**Brown and Bryant**  
**Operable Unit No. 2**  
**Superfund Site**

**Arvin, California**

**Value Engineering Study**

Study Date: January 12-13, 2010

Figure 1 Well Drawing

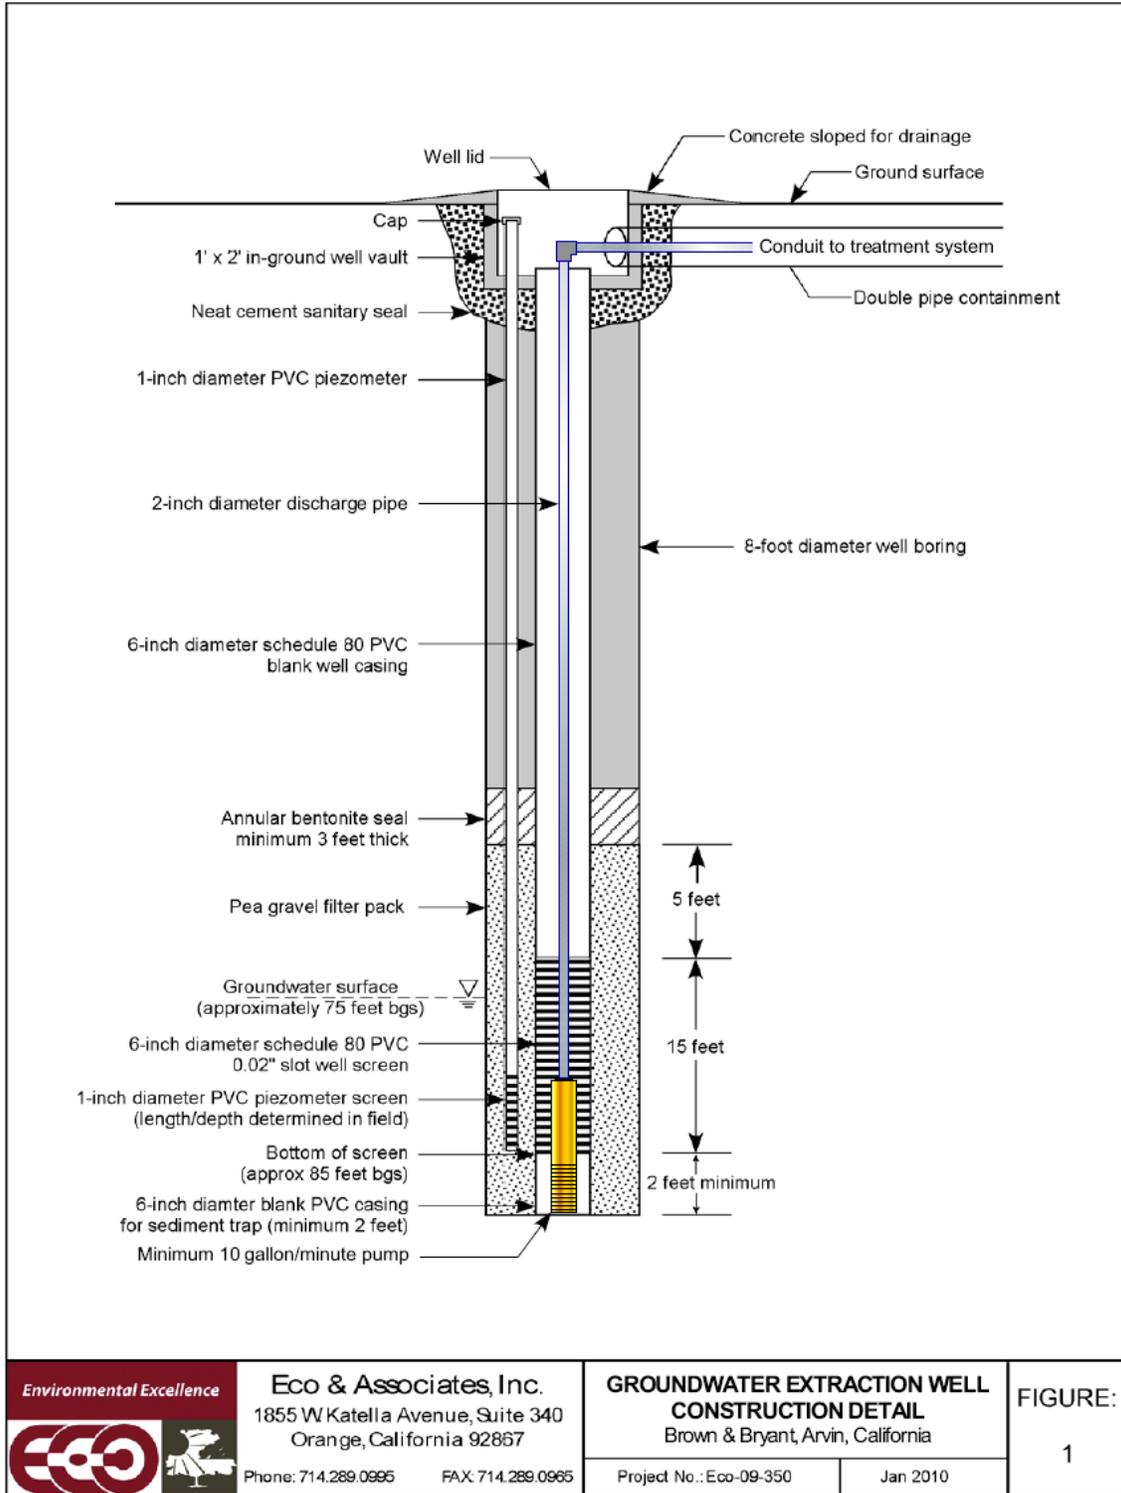
The proposed design is to provide eight foot diameter wells approximately 85 feet below ground surface. The bottom 20 feet have a pea gravel filter pack. The wells will have a 2 inch PVC discharge pipe and an approximate 10 gallon per minute submersible discharge pump. See attached drawing "Groundwater Extraction Well Construction detail by Eco & Associates, Inc., Figure 1.

The need to case the entire length during construction and/or permanently would be the same for either a 36 inch diameter or an eight foot diameter. In fact, a 36 inch may hold during construction and packing the entire height better than an eight foot diameter. The proposed plan does not indicate casing for the entire length. Cost for casing would be less for a 36 inch than for eight foot well.

For cost estimating purposes, an 84 inch caisson belled to eight foot was used as the original design. The actual construction method planned for the eight foot diameter well was unknown, but could be assumed to be considerably higher than the 84 inch belled caisson. Therefore the cost estimate for the "original" designed well could be much higher than estimated.
